ARCHITECTURAL REVIEW BOARD MEETING

PROJECT NUMBER: SP2024-038
PROJECT NAME: Site Plan for Mt. Zion Meter Vault
SITE ADDRESS/LOCATIONS: 3275 N JOHN KING BLVD, ROCKWALL, TX 75032

08/23/2024: SP2024-038: Site Plan for a Municipally Controlled Utility Substation
Please address the following comments (M= Mandatory Comments; I = Informational Comments)

PROJECT NUMBER: SP2024-039
PROJECT NAME: Site Plan for Peachtree Meadows Amenity Center
SITE ADDRESS/LOCATIONS: 1400 CHASTAIN ST, ROCKWALL, TX 75032

5 WEST ELEVATION
ELEVATION

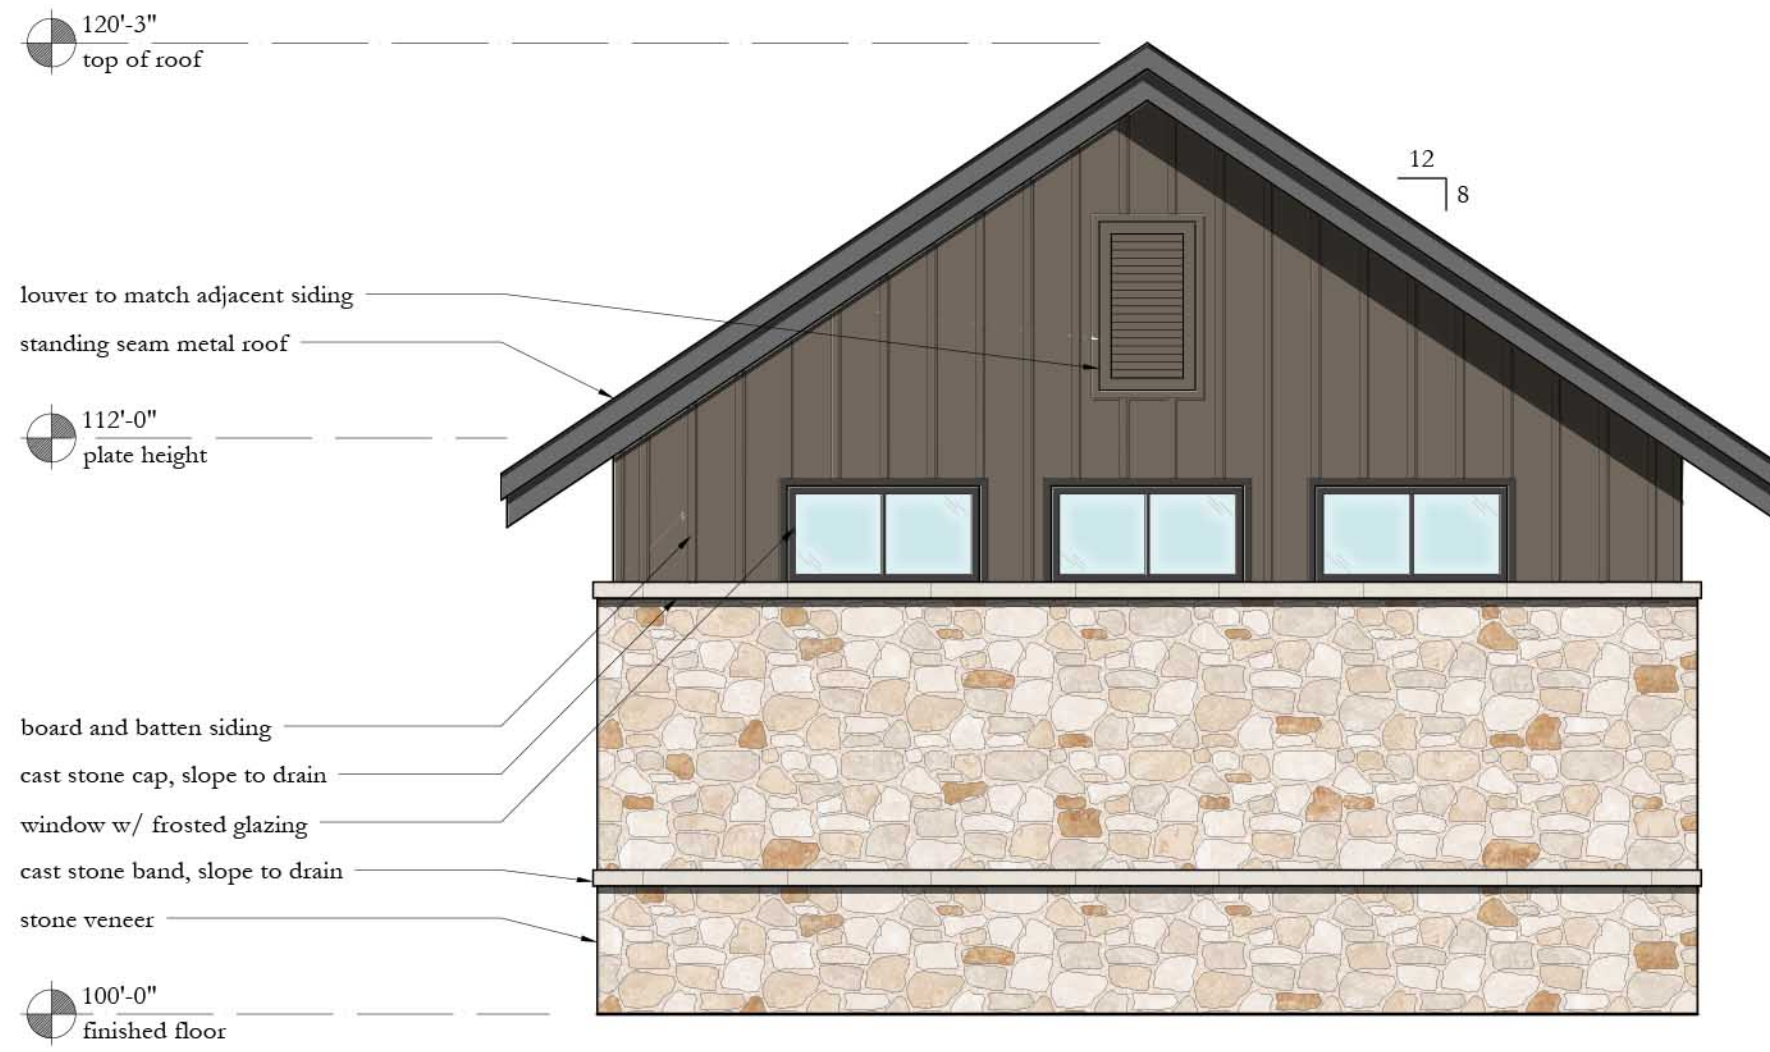
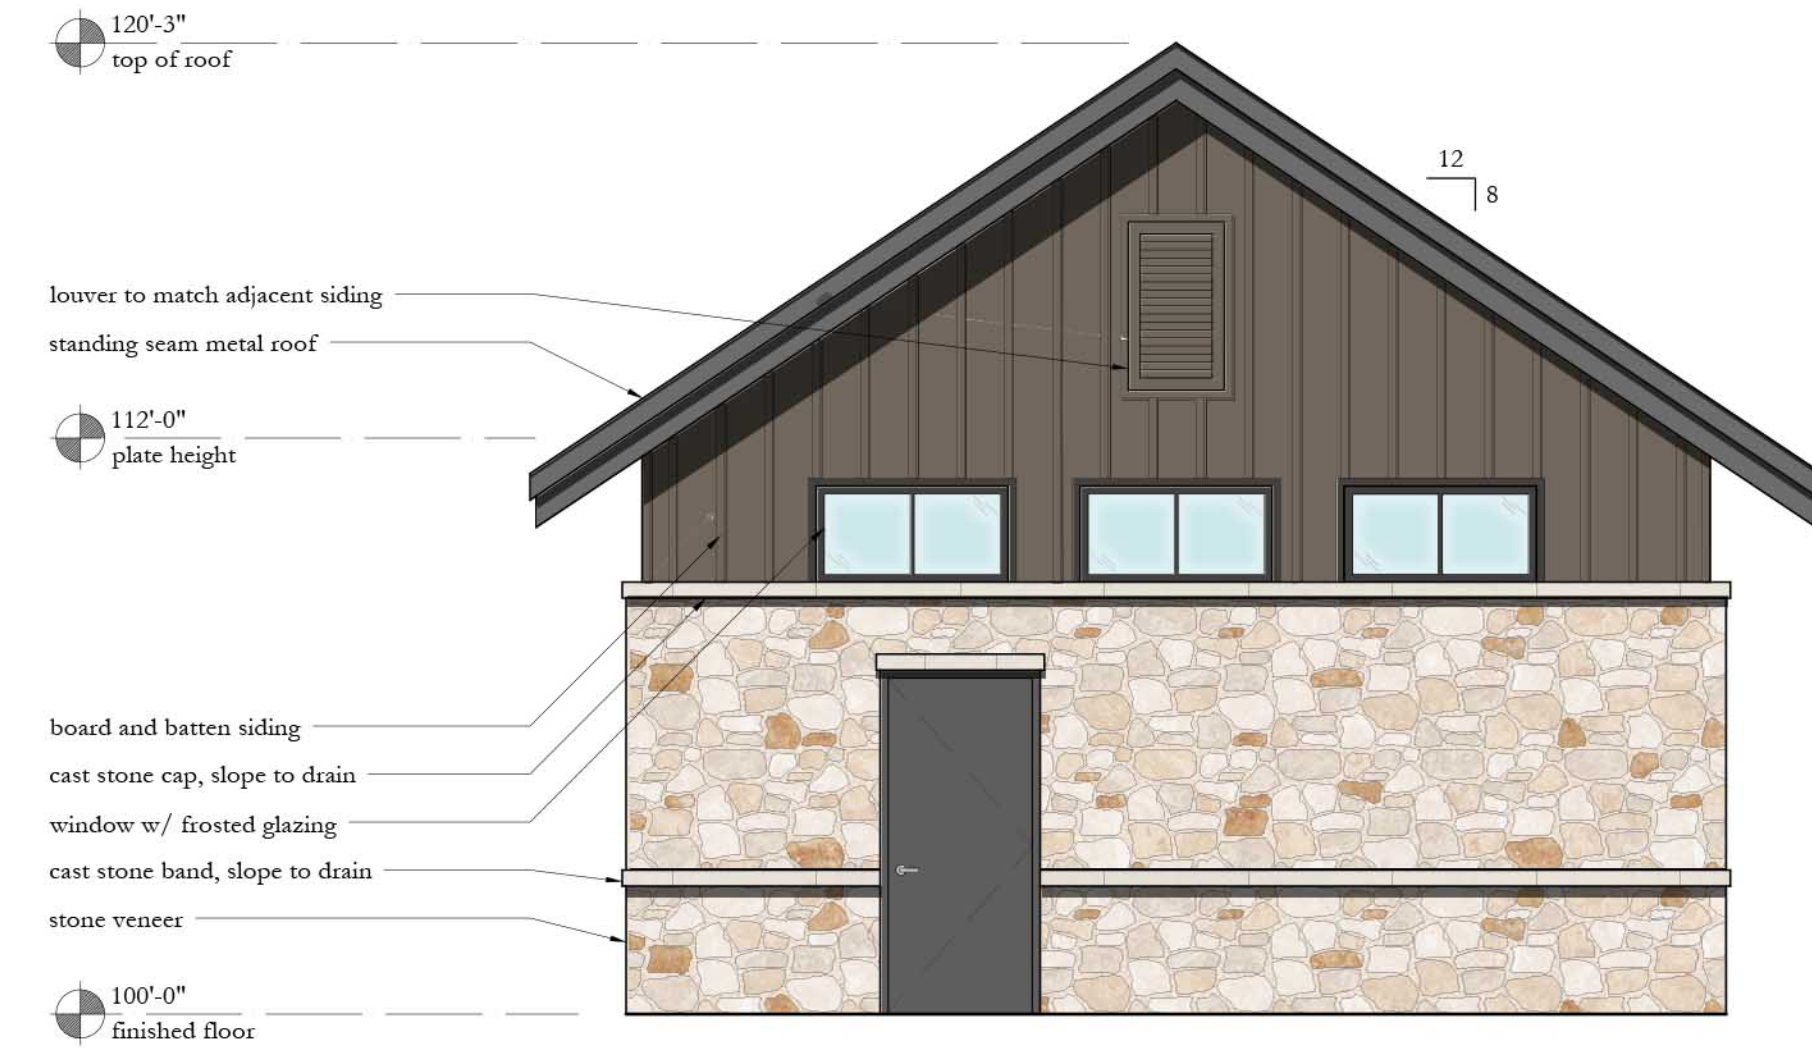
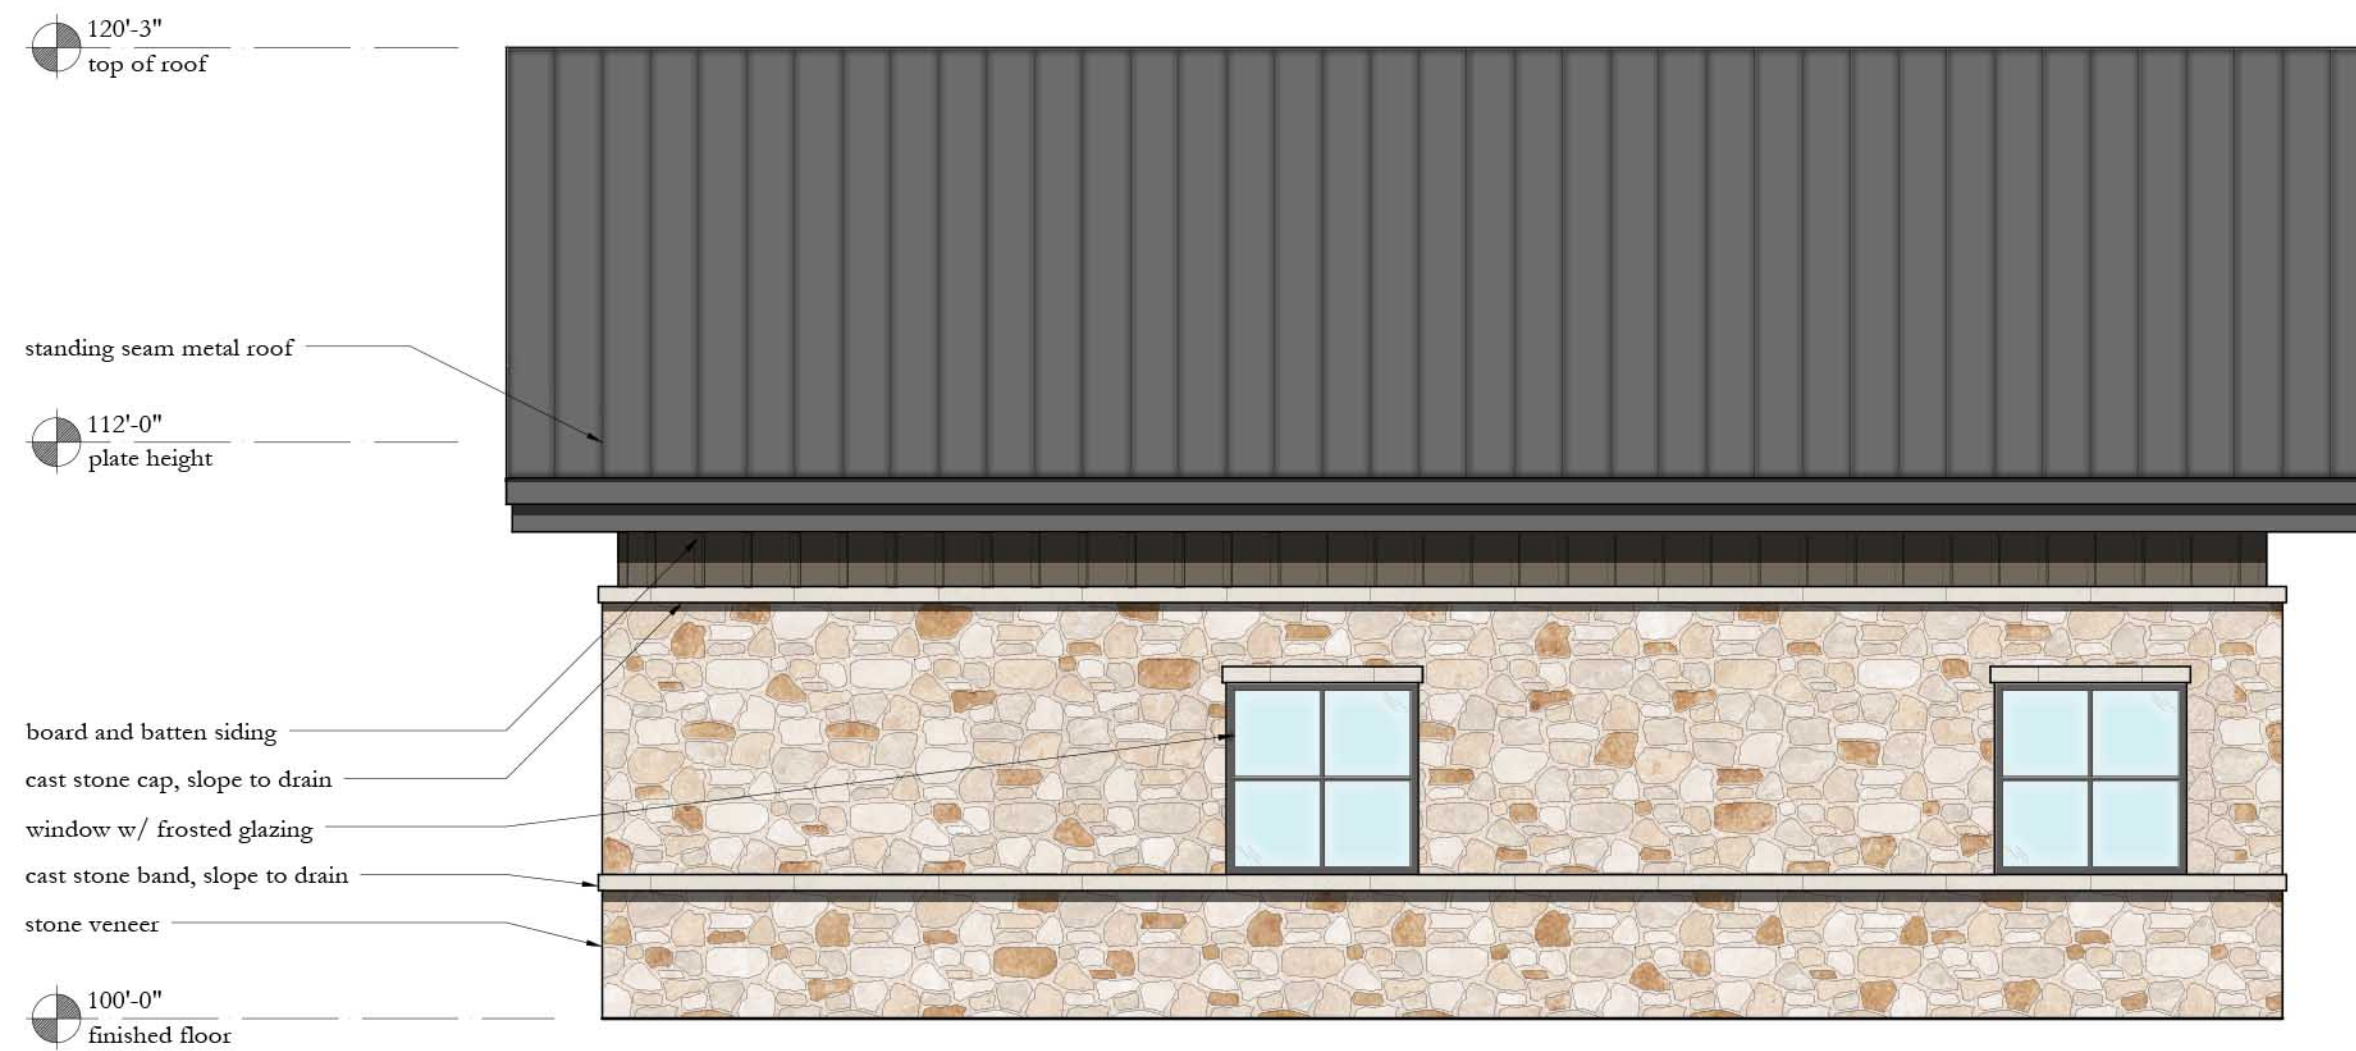
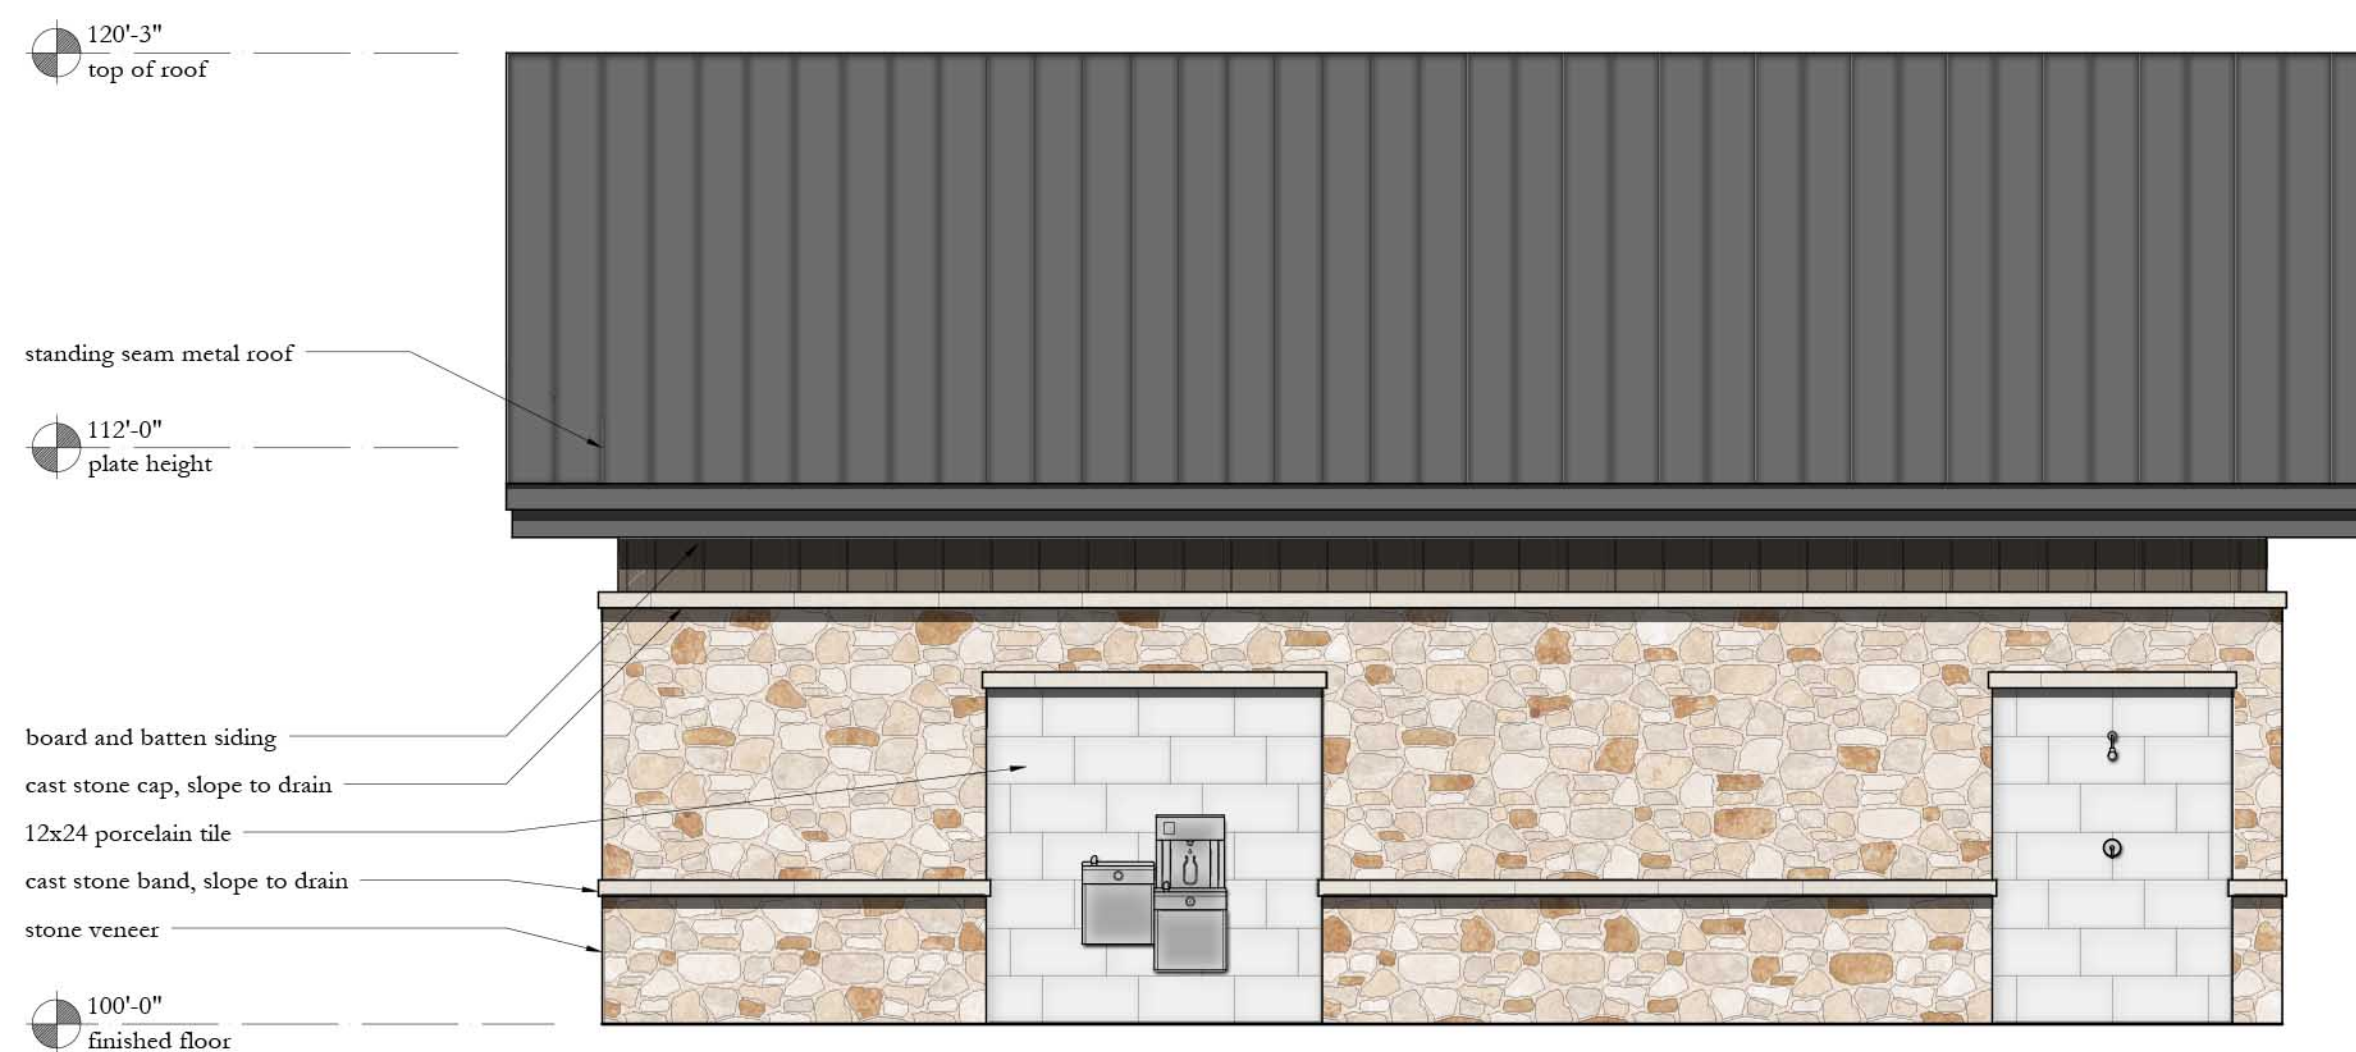
- (1) Please provide elevations of the smaller shade structures. (Ordinance No. 23-11; PD-101)
- (2) Please indicate the roof pitch on the larger shade structure; it must be 8:12. (Ordinance No. 23-11; PD-101)
- (3) The restroom building must have 90% masonry, which is defined as brick and stone in the PD Ordinance. The Ordinance only allows less on the homes. Please revise the building to reflect this. (Ordinance No. 23-11; PD-101)
